PLANNING COMMISSION STAFF REPORT

YWCA Building & Site Design Review

322 East 300 South

Petition #PLNPCM2010-00712

LANDSCAPE PLAN

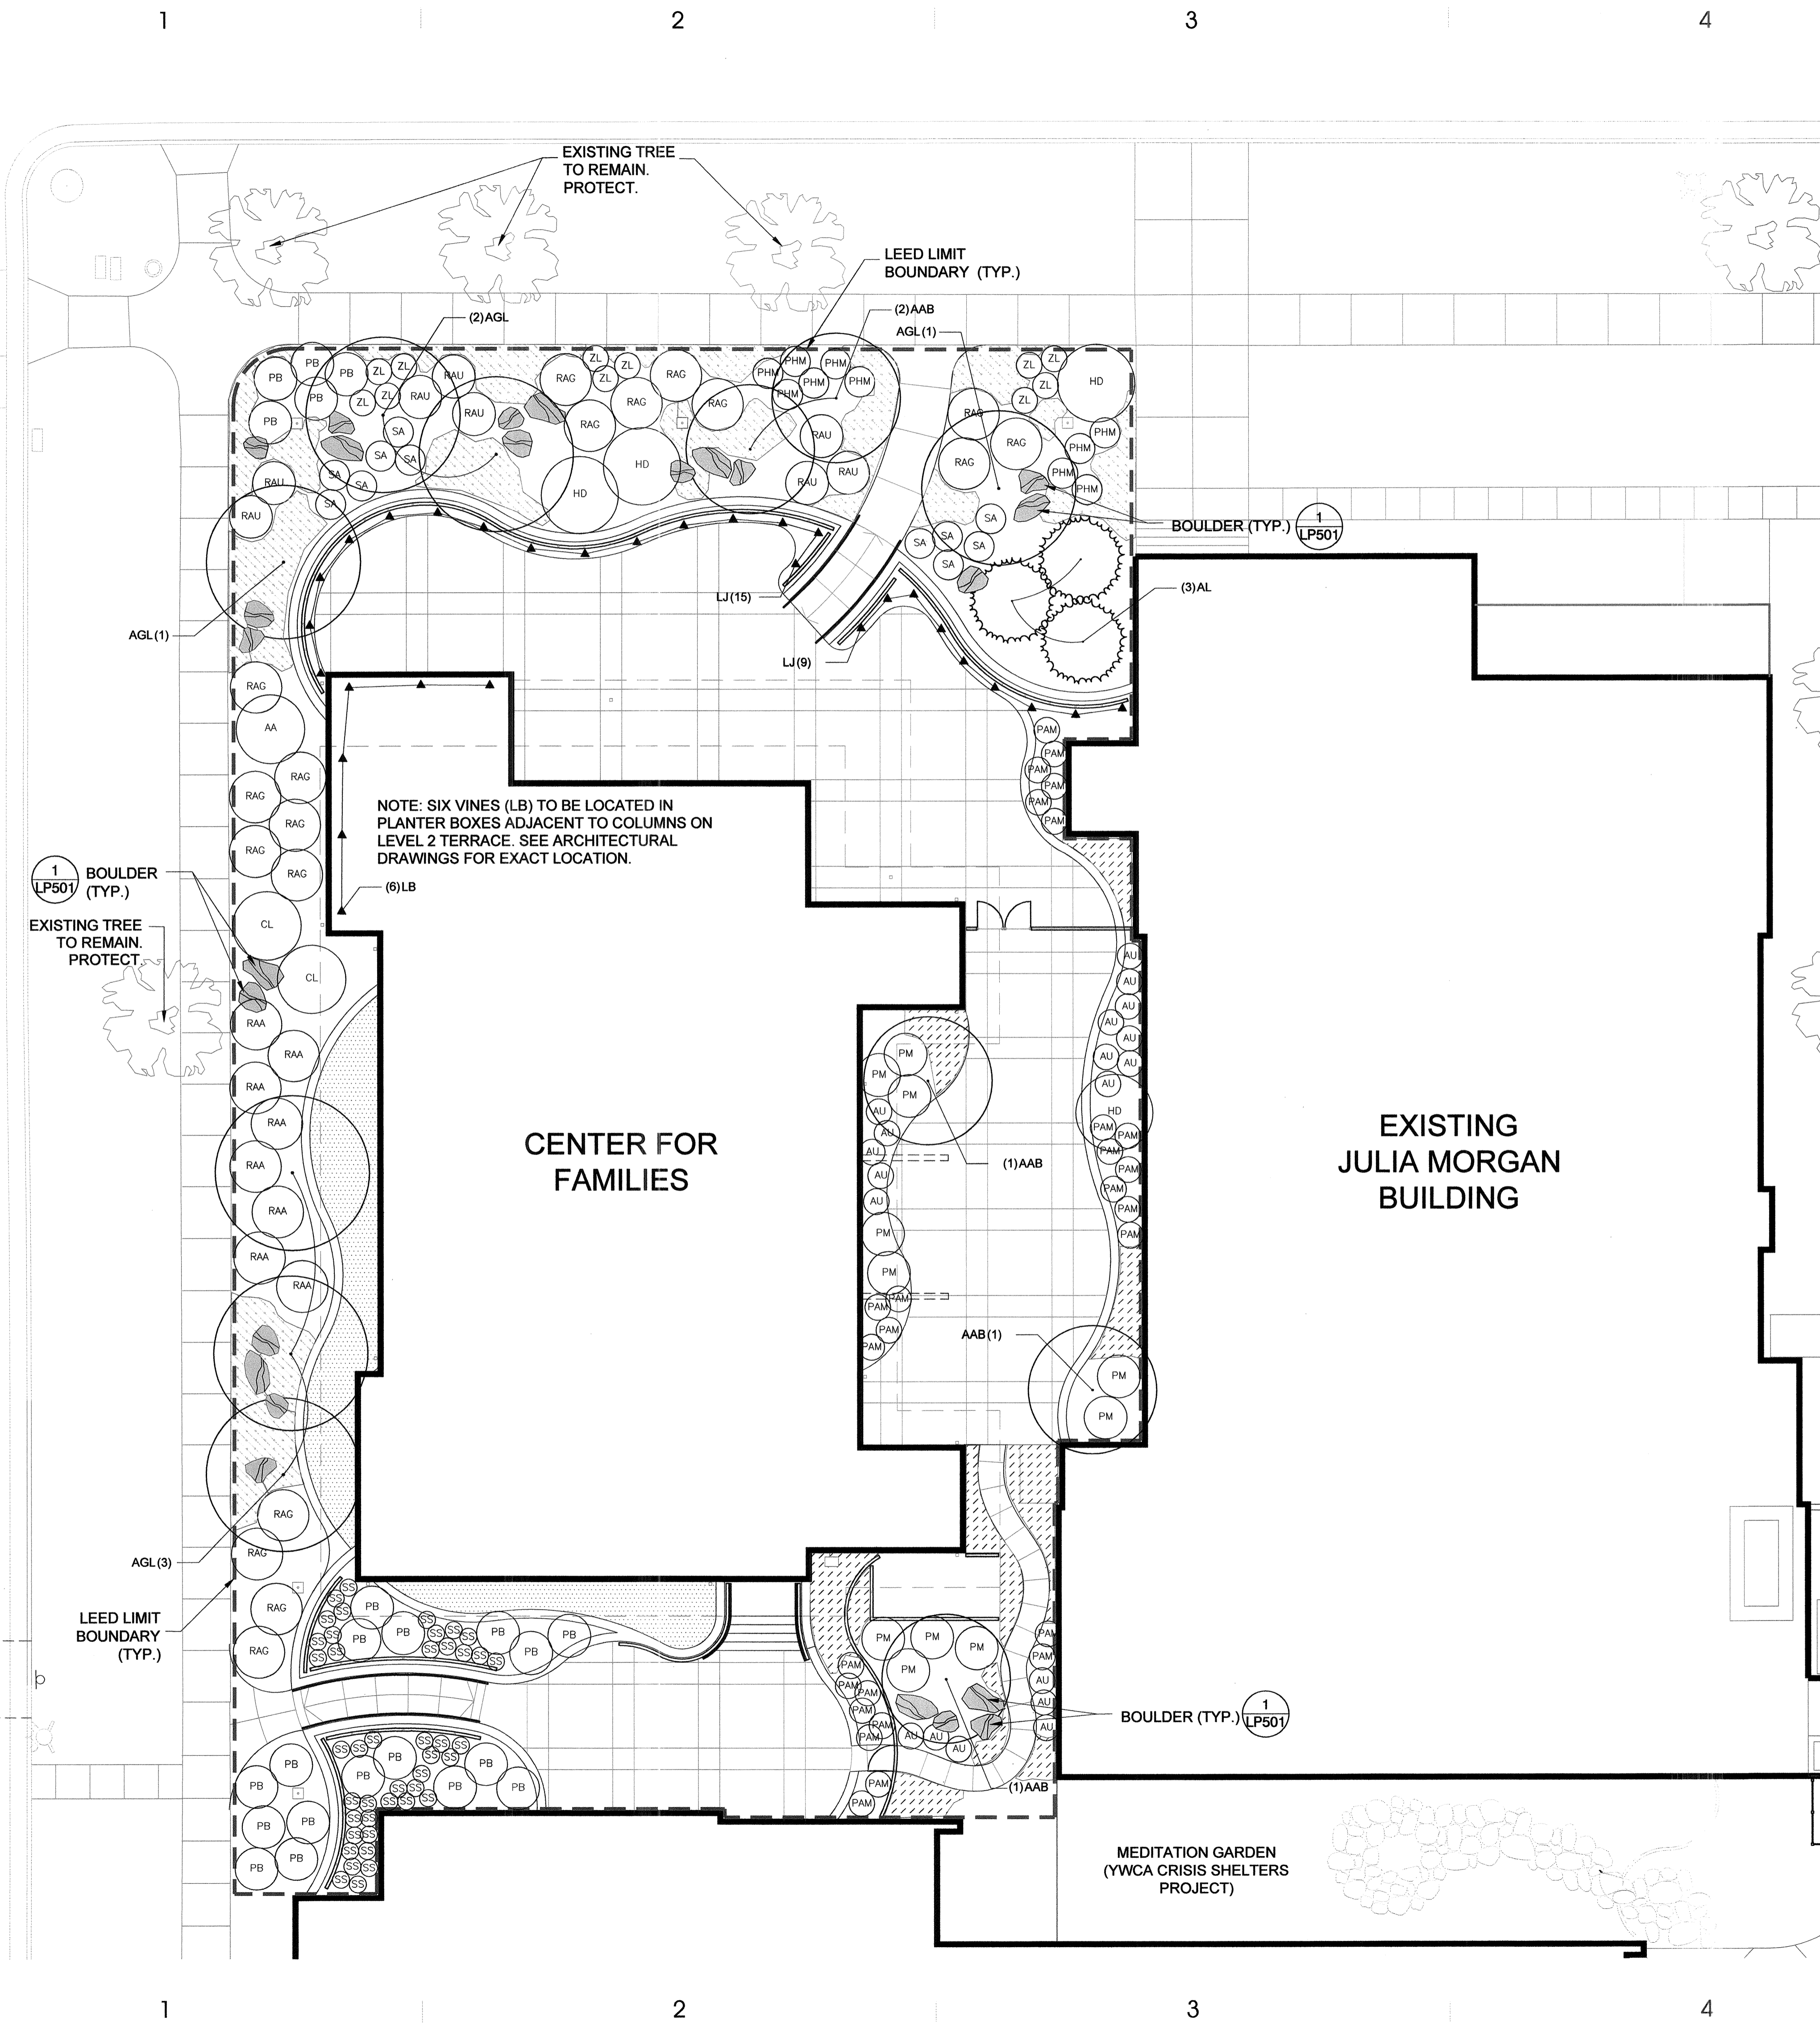
Analysis: There is currently one tree for every 30 feet along 300 South but two additional trees on 300 East are recommended by staff (see Standard L below). Most of the property has mature landscaping that will be protected through the redevelopment of the northwest corner of the property and staff believes that the landscaping in both front yards will be in place within three years. Colored concrete is proposed for designating public walkways and the building's entrance, and a stone wall is proposed in front of the building on 300 South to provide some separation between the public and private spaces and to provide security for the YWCA's users and employees. There are no outdoor storage areas in sight from the street and the only residential areas adjacent to this building are across 300 South and 300 East. No details regarding the landscaping and tree types have been provided, but their suitability and variety is a condition of the recommendation of approval.

Analysis: To staff's knowledge, no trees will be removed as a result of this development. There are existing three existing trees in front of the proposed building along 300 South and one trees on 300 East. Staff recommends the placement of two additional trees—one on either side of the existing tree—along the 300 East frontage to create a more consistent look for the corner.

1. Additional street trees shall be placed on the 300 East park strip in front of the proposed building.
2. The applicant shall provide staff with a list of the trees, shrubs and flowering plants to be used in the site's landscaping.

SHEET NUMBER:
 AE201

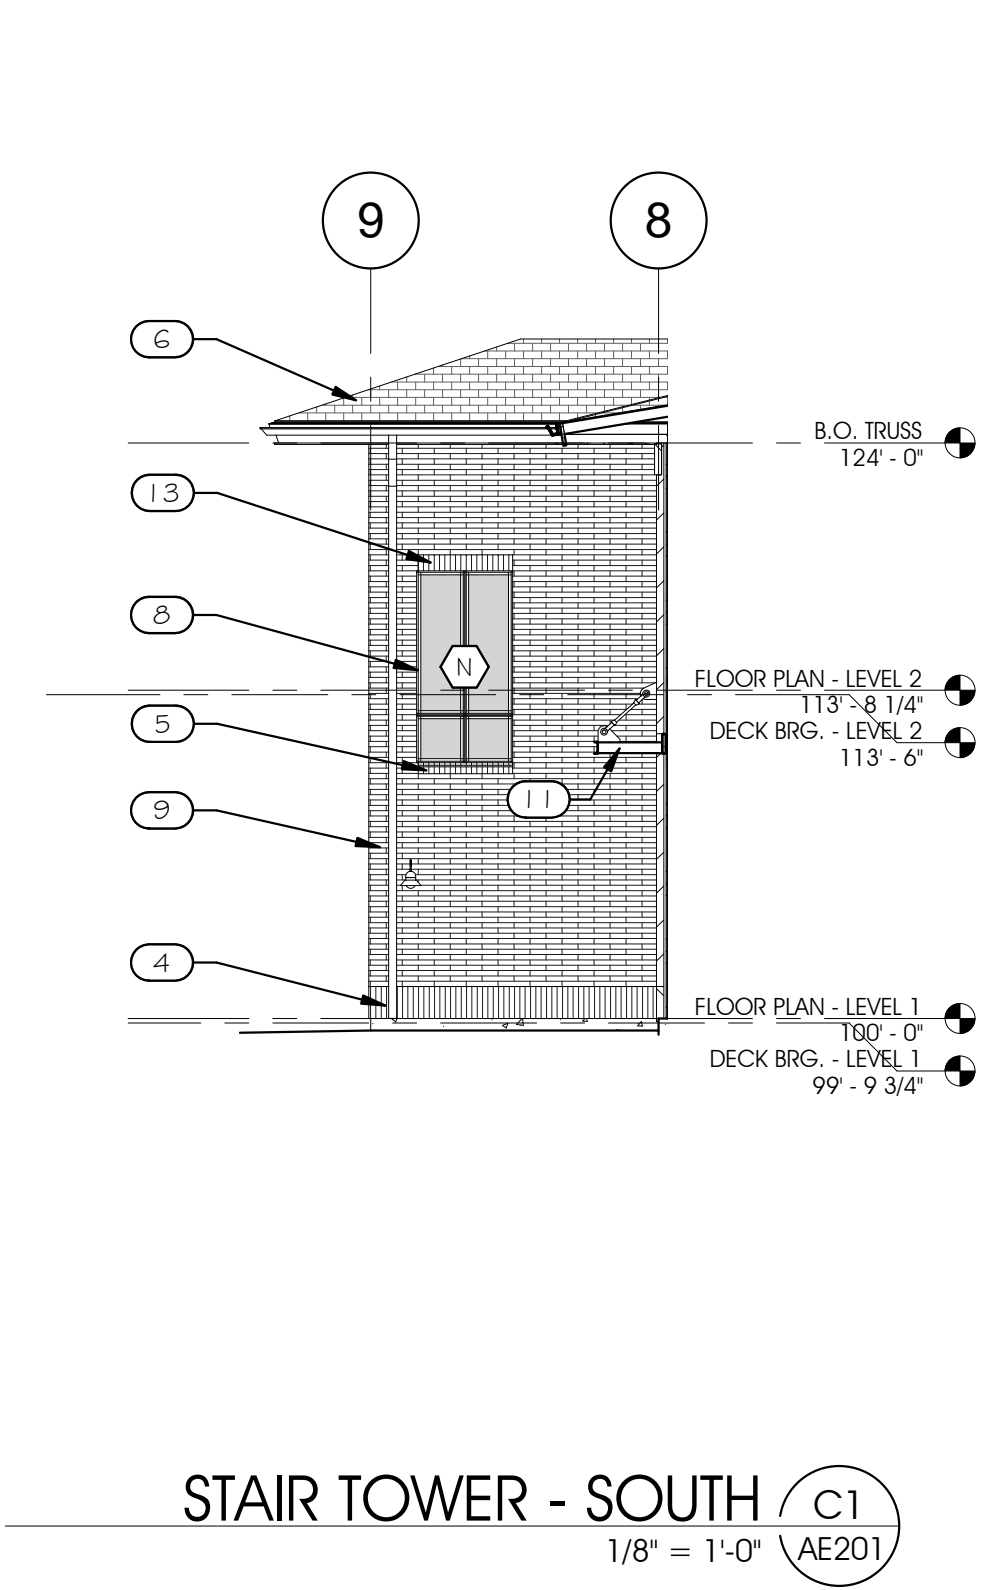
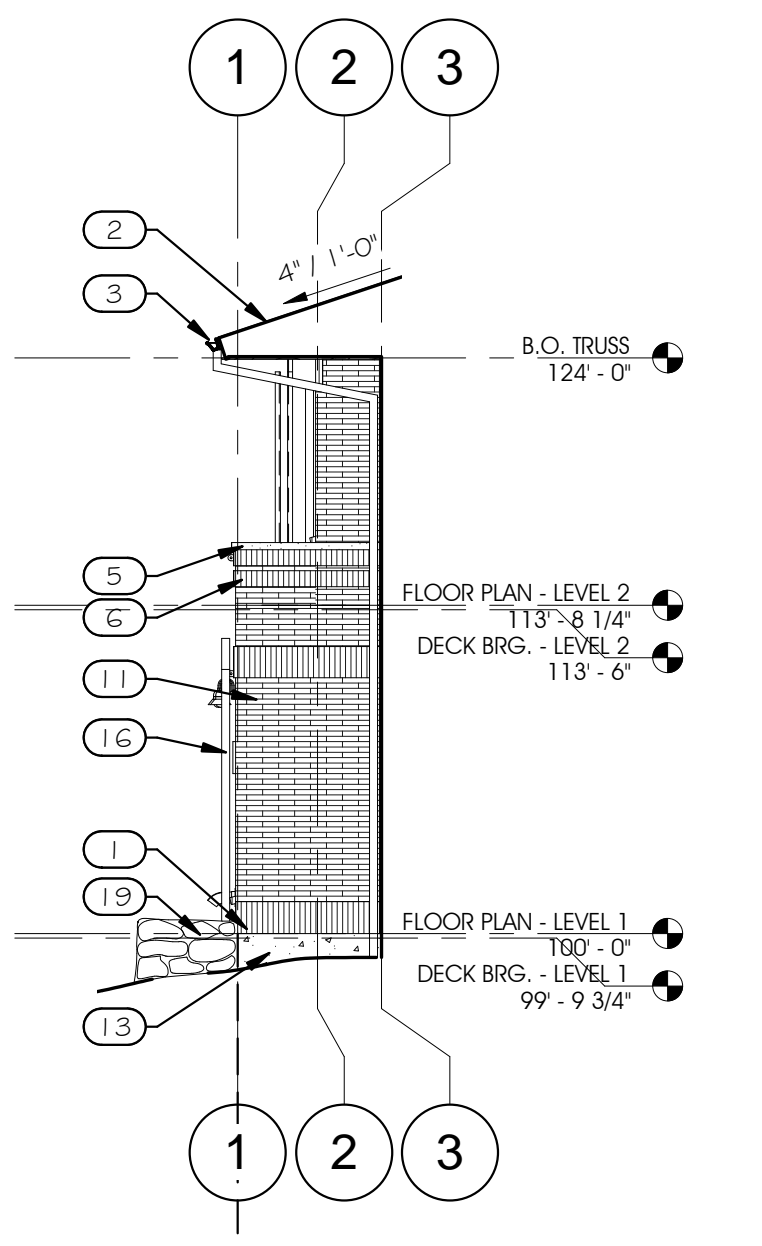
The 40 percent glazing requirement applies to both the west elevation (300 East) and the north elevation (300 South) because the proposed building has two front façades. The west elevation has 479 square feet of glazing which is 38.9 percent of the façade. The north elevation has 289 square feet of glazing, which is 36.4 percent of the façade. The glass on the first floor of both elevations is non-reflective, as required by the ordinance.

Analysis: Neither of the first floor walls are within 30 feet of their respective streets. However, both façades contain at least 35 percent non-reflective glass windows. Most of those windows will allow views of the lobby or working areas, but the windows will have blinds or shades if there are privacy concerns. Neither of the front façades would be considered "monolithic" in nature as the walls have recesses and windows. Additionally, both walls facilitate pedestrian interest to a reasonable extent despite the additional setback. The northwest corner of the proposed building's second floor is a veranda that looks out over the front yards and the intersection of 300 South and 300 East.
